Re: NYISO 2021-2025 ICAP Demand Curve Reset Process  
Comments on NYISO Staff Final Recommendations

**Comments of GenOn Bowline, LLC and GenOn Energy Management, LLC  
on NYISO Staff Final Recommendations for the 2021-2022 ICAP  
Demand Curves and the Parameters for the  
2021-2025 Demand Curve Reset Process**

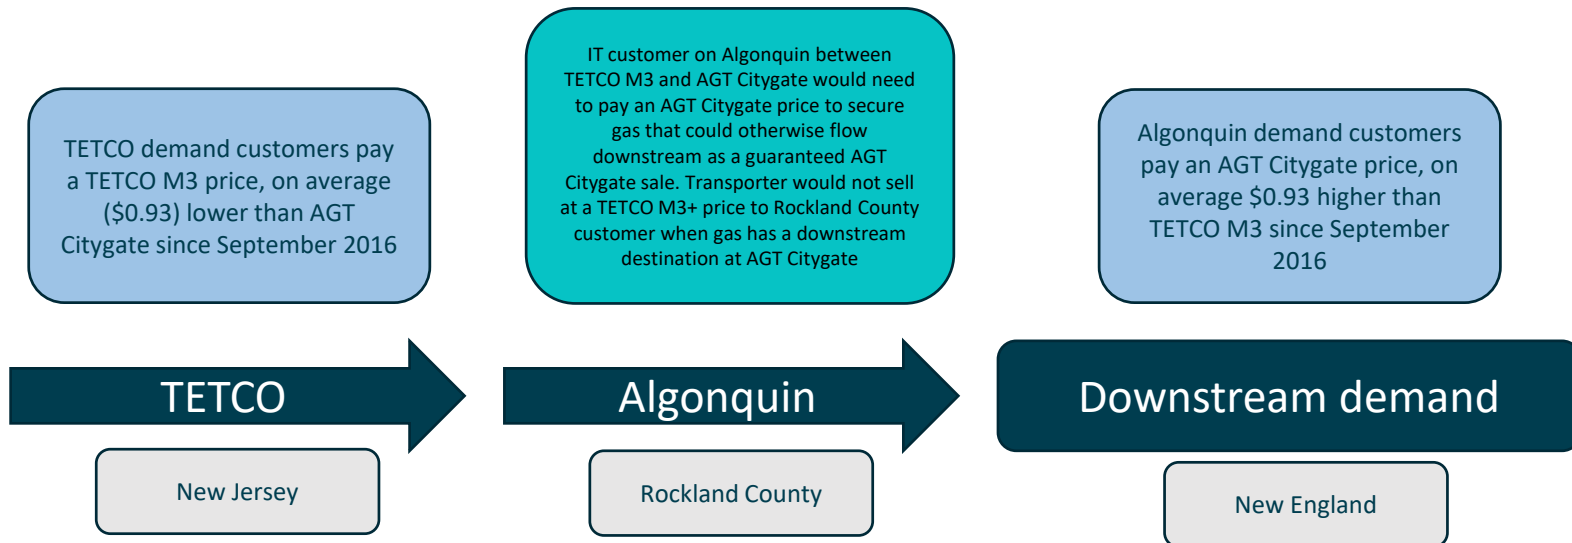
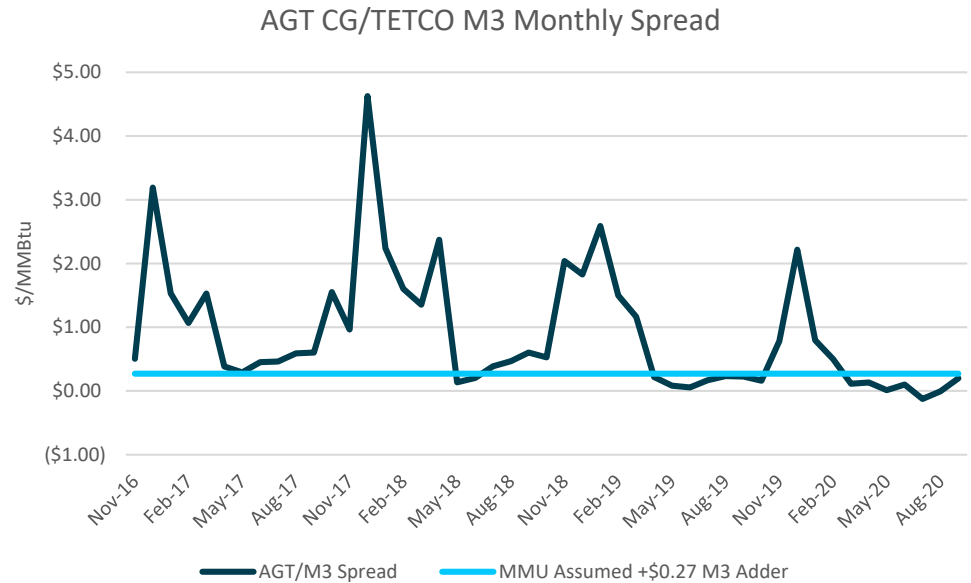
In the winter, IT capacity is rarely available due to FT and No-Notice demand service taking precedent, resulting in significantly wider spreads between AGT and TETCO M3 of \$1.61/MMBtu on average reflecting the scarcity of capacity. Transport cost of \$0.27/MMBtu between TETCO M3 and AGT is not representative of winter dynamics due to this scarcity and inability to secure consistent IT service.

AGT CG/TETCO M3 Monthly Average Spread (\$/MMBtu)	
Winter '16/'17	\$1.56
Summer '17	\$0.62
Winter '17/'18	\$2.16
Summer '18	\$0.67
Winter '18/'19	\$1.82
Summer '19	\$0.16
Winter '19/'20	\$0.88
Summer '20	\$0.05

### Correlation to Zone G

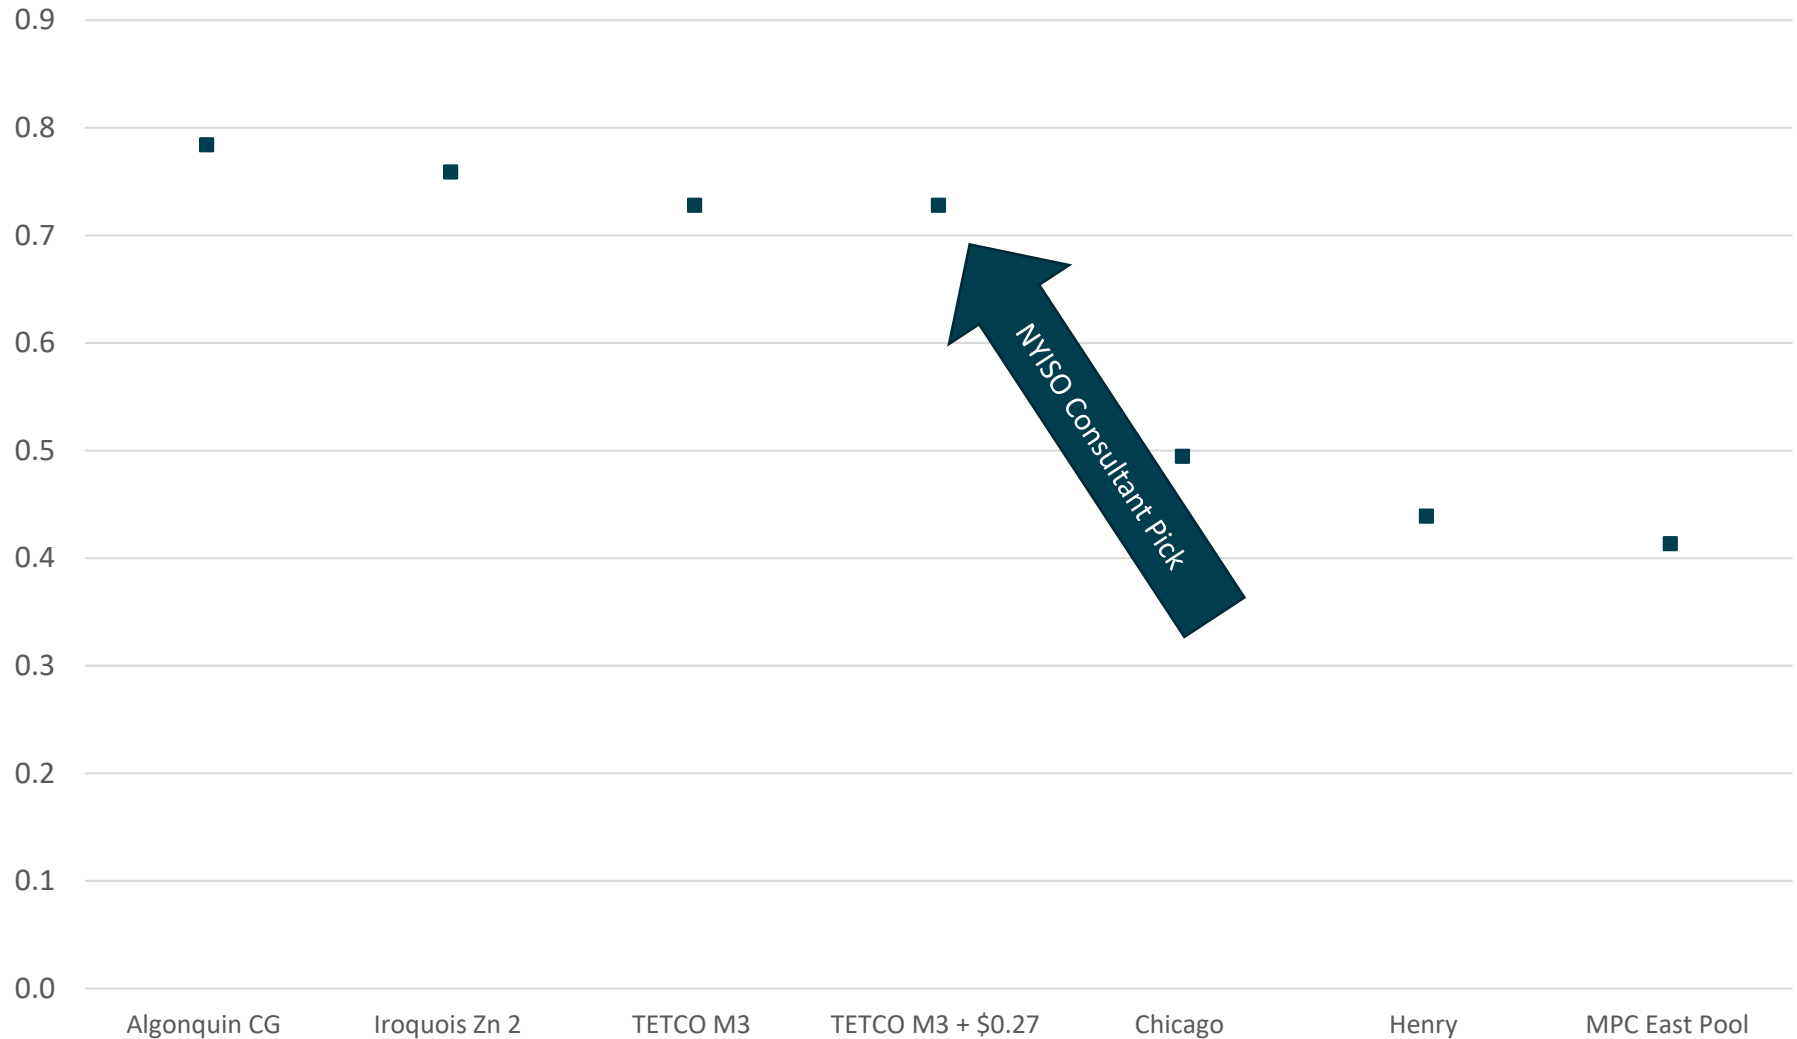
**Market Dynamics:** Northeast gas pricing point vs. NYISO LBMP pricing show consultant's picks based of correlation was third best pick based on this analysis

## Monthly Modeled Generation Scenarios

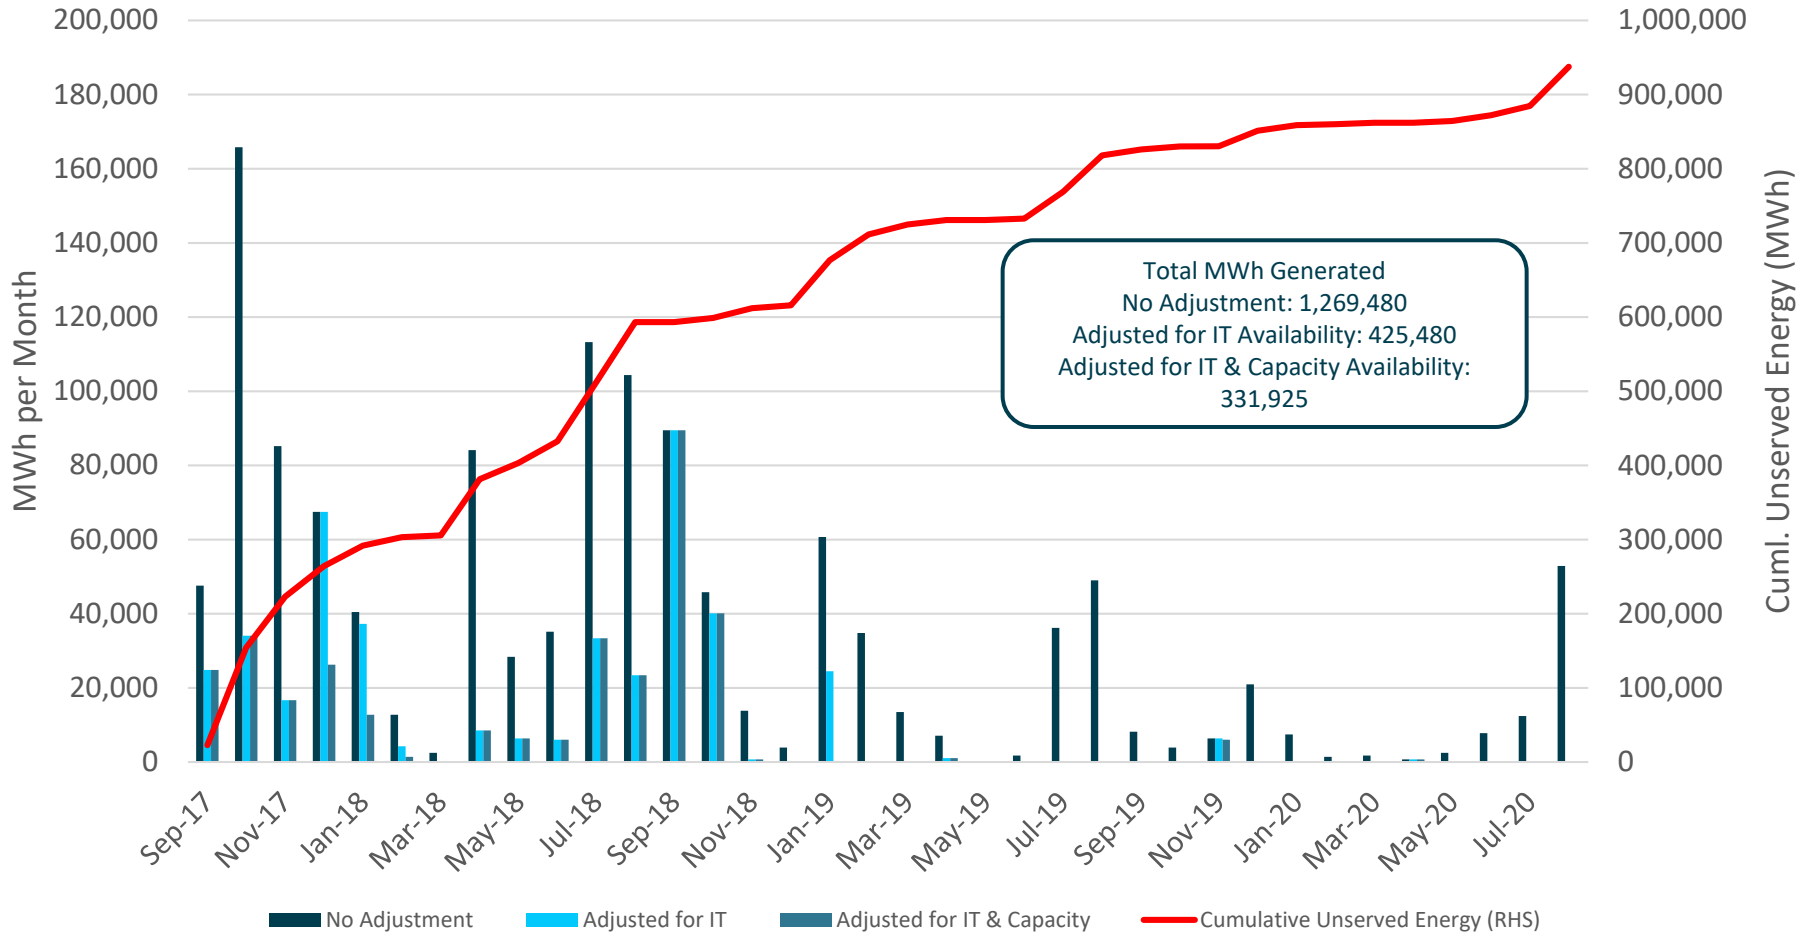
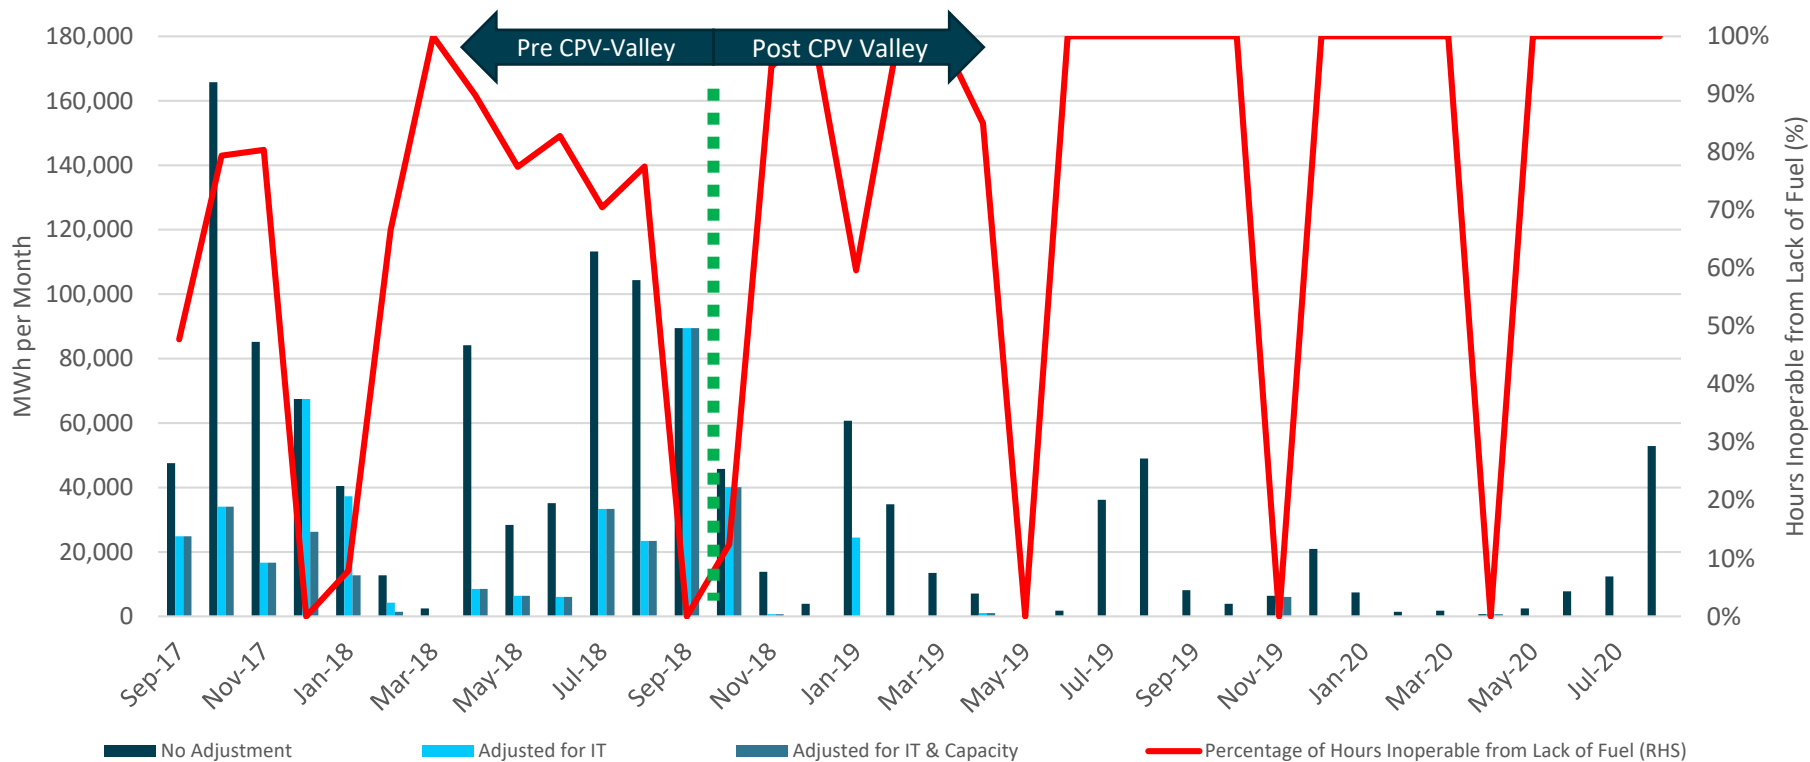
Based upon this analysis, when the constraints faced by the proxy peaking plant due to unavailable interruptible transportation service and lack of pipeline capacity are properly taken into account, the total MWhs generated by the proxy peaking plant in the G-J Zone during the three-year historic period drop precipitously. Specifically, for the period September 1, 2017 through August 31, 2020 used to set the 2021-2022 ICAP Demand Curves, hours were removed where interruptible transportation service could not be scheduled. Accurately accounting for the interruptible transportation service that was actually available over this period causes the total MWh generated by the proxy peaking plant to plummet by 66.5% from the 1,269,480 MWh

calculated by the Consultants to 425,480 MWh, *i.e.*, the proxy peaking plant would only operate in roughly one third of the hours currently projected in the Consultants' model.<sup>60</sup>

Since the start of CPV Valley, a power plant attempting to secure IT on AGT would have seen expected generation drop by 97.5% given constraints on AGT and availability of IT compared to MMU model that assumes TETCO M3 Pricing and that IT is always available

Total MWh Generated – Total Period  
(Sept 2017 to Aug 2020)  
No Adjustment: 1,269,480  
Adjusted for IT Availability: 425,480 (66.5% Reduction)  
Adjusted for IT & Capacity Constraints: 331,925  
(73.9% Reduction)
